SUBJECT: NuScale Power, LLC Supplemental Response to NRC Request for Additional Information No. 332 (eRAI No. 9245) on the NuScale Design Certification Application

Response to Request for Additional Information Docket No. 52-048

eRAI No.: 9245

NRC Question No.: 12.03-8

Figure 2 Control Rod Drive Shaft Base

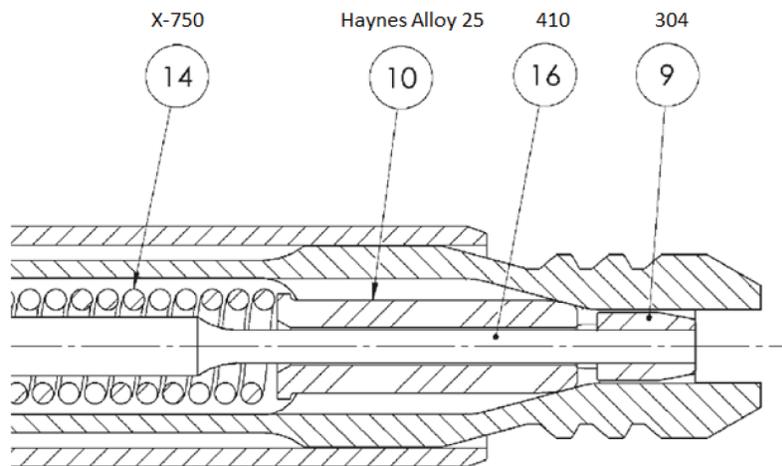
The design documents reviewed by the NRC staff during the CRDM Audit, indicated that due to the length of the control rod drive shaft and the expected deceleration forces expected during control rod dropping, that there was a potential for increased flexure at the control rod drive shaft to control rod assembly junction. The applicant stated that the design of the CRDMs was not complete, so future design work and testing of this junction was expected. Since the applicant is currently unable to provide additional information regarding how increased flexure of this junction could affect cobalt introduction rates, the staff was not able to identify how the expected extra wear at this junction was factored into estimating the introduction of cobalt-

Since the applicant is currently unable to provide additional information regarding how increased flexure of this junction could affect cobalt introduction rates, and because cobalt is a major source of radiation exposure in operating nuclear power plants, increased wear of cobalt containing material will increase operational radiation exposure, contrary to the requirements of 10 CFR 20.1101(b) and fails to minimize contamination in accordance with 10 CFR 20.1406.

1. Explain/justify the amount of allowable flexure for the control rod drive shaft, including the limiting number of cycles, the basis for the stated flexure value, and the expected material wear rates,
2. Explain/justify the testing that will be performed to assess the actual amount of control rod

drive shaft flexure,

3. As necessary, revise and update section 12.3 of the NuScale DCD to specify the design features of the control rod drive shaft provided to minimize the introduction of cobalt due to flexure,

The Cobalt item, at the base of the control rod drive shaft, is the coupling expansion plug, item 10, depicted in Figure 2. The design of this latching interface is similar in form and in material to the control rod latching mechanisms in service in the existing fleet. In these existing applications Haynes Alloy 25 has proved to be the appropriate material for these applications. Since this item is inside the control rod drive shaft, there will be very little motion due to any shaft bending (flexure) motion during a SCRAM. The vertical motion is also expected to be similar to that of similar mechanisms in the existing fleet. Industry experience has shown that Haynes Alloy 25 is the appropriate material for this application.
